HIROSE ELECTRIC CO., LTD.
2-6-3 Nakagawa Chuoh, Tsuzuki-ku, Yokohama, JAPAN

Product Change Notification

■Product list PCN2022-07_PQ50S series shape change

■ [Changes] Shape Change

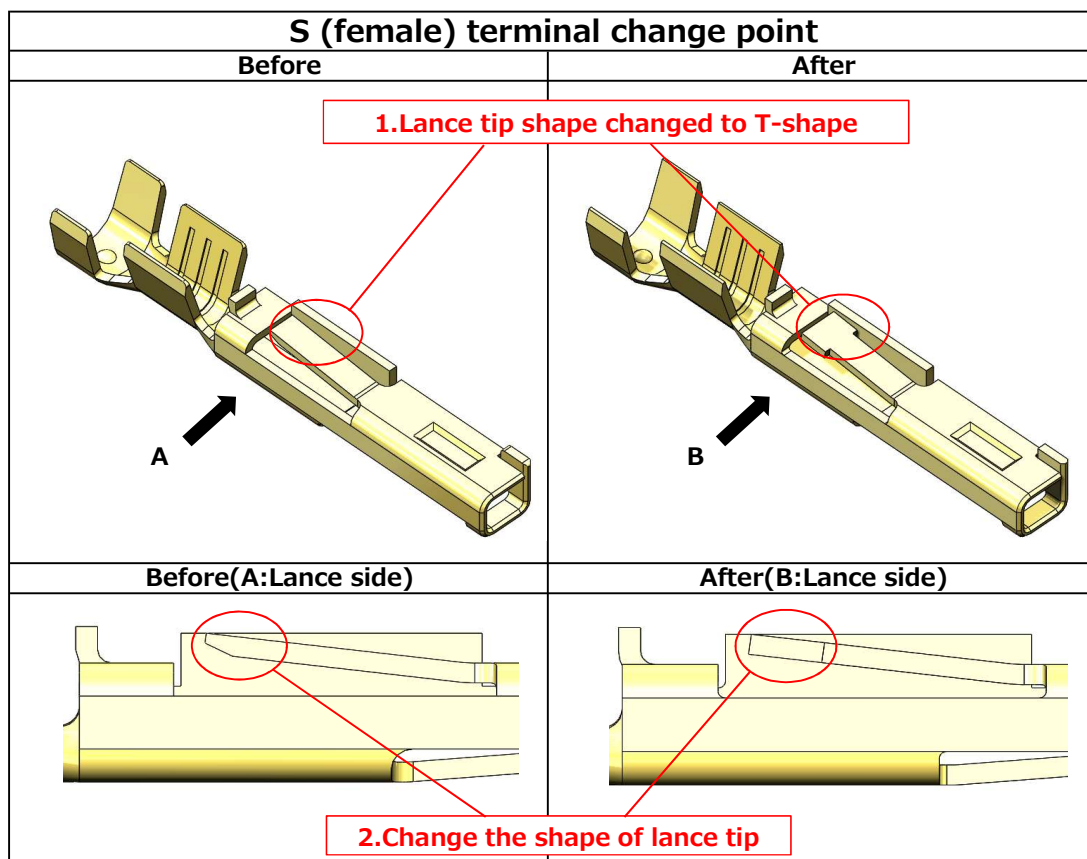
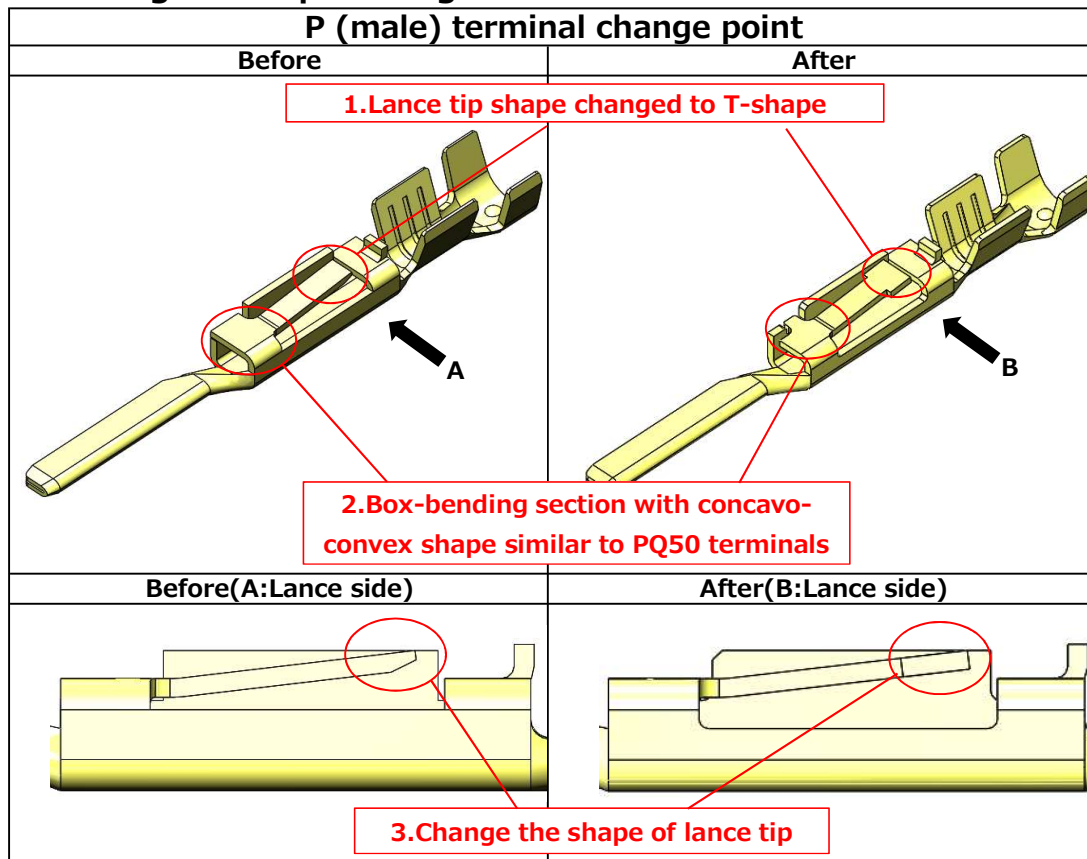
1	Products affected	PQ50S series *Please refer to the attachment1 for detailed product names.
2	Replacement product	PQ50S2 series *Please refer to the attachment1 for detailed product names.
3	Classification of change	Product shape change.
4	Changes	The shape of the crimp terminal will be changed to strengthen the terminal fixing force. Please refer to the attachment2 for details. There are no other differences in product performance or changes in the specifications sheet due to the change.
5	Reason for change	The shape of the crimp terminal will be changed to improve the fixing strength of the terminal.
6	Date of final reception of orders for the current product	September 29,2023
7	Date of the first reception of orders for the replacement product	July 31,2023
8	Date of final shipment of the current product	March 29,2024
9	Date of your acknowledgement	By February 28,2023
